Project	IEEE 802.16 Broadband Wireless Access Working Group < http://ieee802.org/16 >	
Title	Comments on AWD Downlink Control Structure	
Date Submitted	2009-07-06	
Source(s)	Yih-Guang Jan, Yang-Han Lee, Hsien-Wei Tseng, Ming-Hsueh Chuang, Jheng-Yao Lin Tamkang University (TKU)	yihjan@yahoo.com
	Youn-Tai Lee, Chun-Yen Hsu Institute for Information Industry (III)	lyt@nmi.iii.org.tw
	Shiann-Tsong Sheu National Central University (NCU)	stsheu@ce.ncu.edu.tw
	Whai-En Chen National Ilan University (NIU)	wechen@niu.edu.tw
Re:	802.16m amendment working document "Comments on AWD 15.3.6 Downlink Control Structure"	
Abstract	Comments on AWD Downlink Control Structure	
Purpose	To be discussed and adopted by TGM for the 802.16m AWD.	
Notice	<i>This document does not represent the agreed views of the IEEE 802.16 Working Group or any of its subgroups. It represents only the views of the participants listed in the "Source(s)" field above. It is offered as a basis for discussion. It is not binding on the contributor(s), who reserve(s) the right to add, amend or withdraw material contained herein.</i>

Comments on AWD Downlink Control Structure

Figure 481—TBCC encoder of rate 1/4

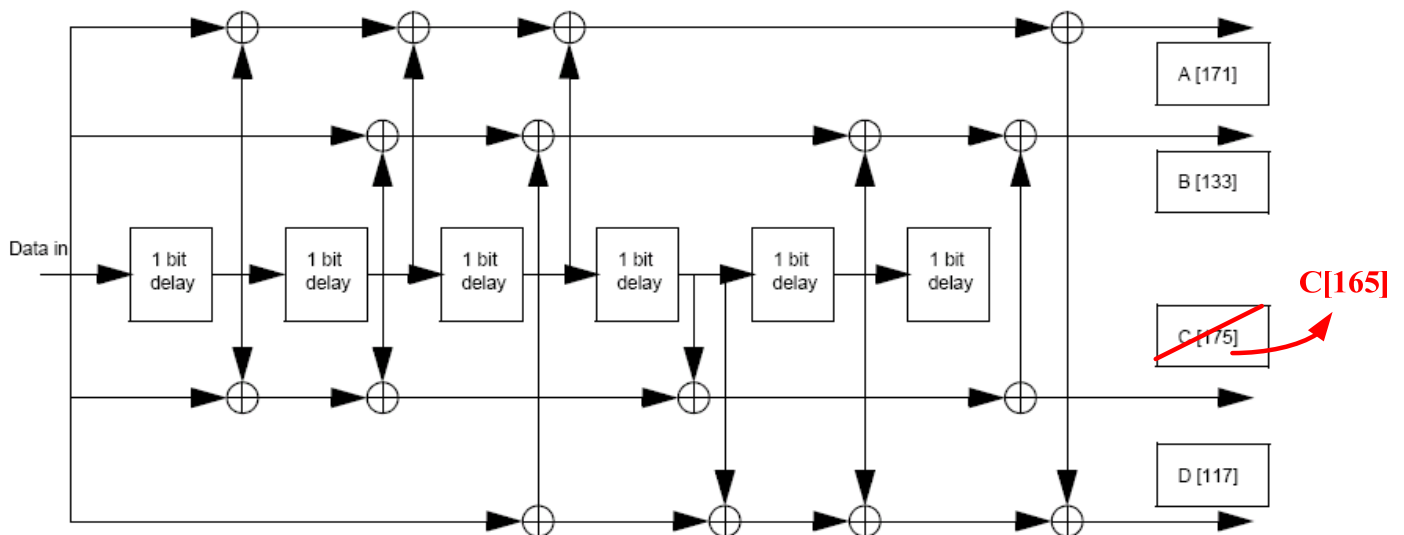
This contribution provides the corrected AWD text proposal to Subblock interleaver. In Figure 481, it has an error and needs correction.

[In IEEE 80216m-08_0010r2, Section 15.3.6.3.3.3, replace the original five bits for subblock C by its corrected bits.]
